**NUMBER:** 21-038-20

**GROUP:** 21 - Transmission and Transfer Case

Transmission Case Oil Leak

This bulletin involves tightening the lower transmission bolts to updated torque specifications to possibly eliminate a leak at the case split line of the transmission.

Fig. 4

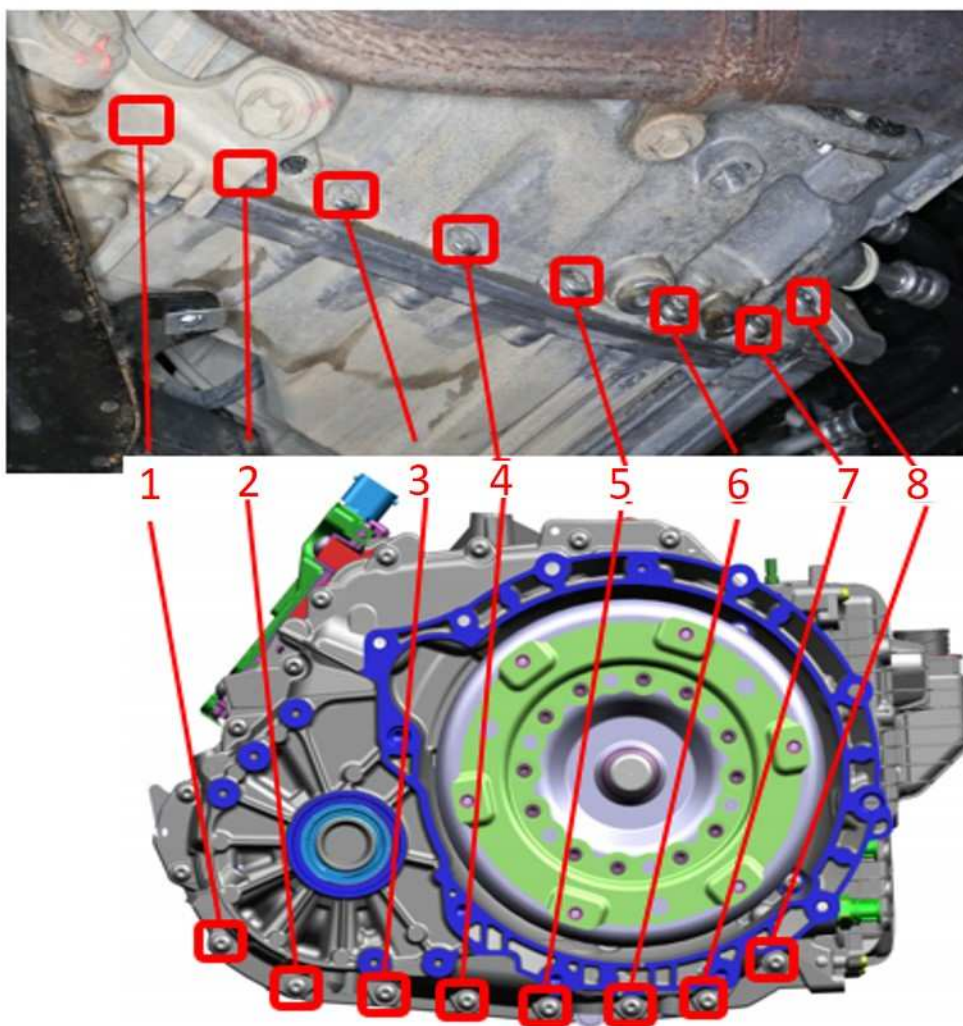
3. Starting at bolt #8 and then working to bolt #1, torque bolts to 35 N·m (26 ft. lbs.) (Fig. 4) .

**CAUTION! Do not rotate the bolts counter clockwise.**
